## Quality Assurance (Management Measures) RAIs

**Figure 11-2 Plant Operation Organization**

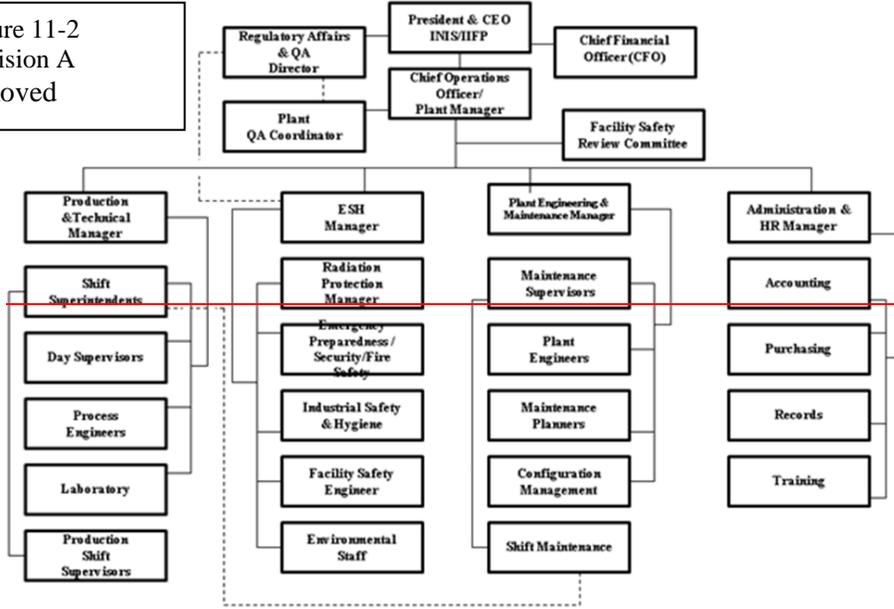
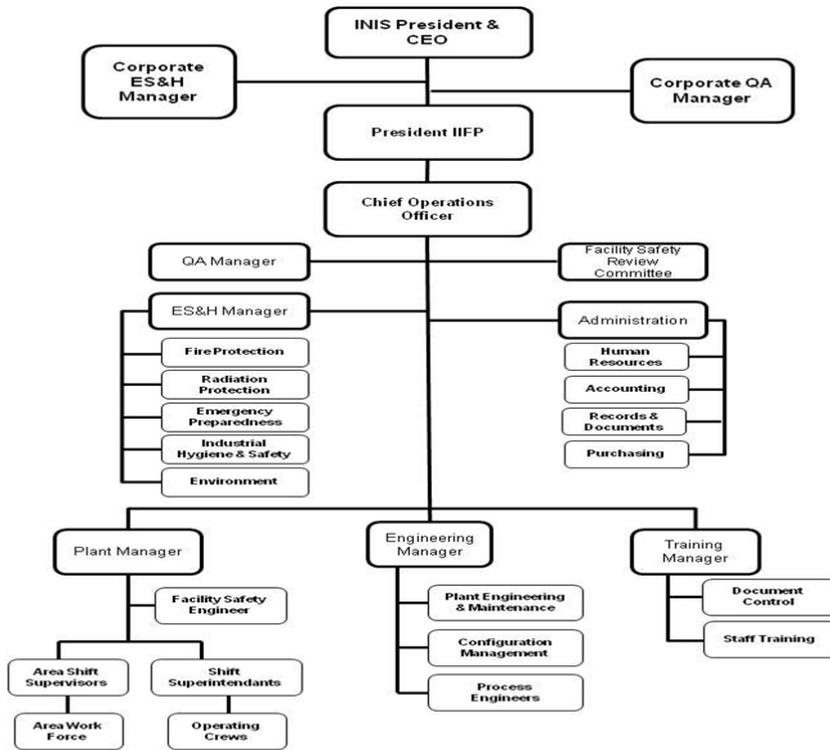
Figure 11-2 “IIFP Plant Organization during Operations of the FEP/DUP Facility” will be removed and replaced with Figure 11-2 “Plant Operation Organization” depicting the organizational structure of the Facility, in response to RAI OA-7A.

**License Documentation Impact:** Remove Figure 11-2 and title and replace with revised Figure 11-2 "Plant Operations Organization" in the Chapter 11 of IIFP License Application, Revision A, (also in response to RAI OA-7) the revised Figure and will appear as follows:
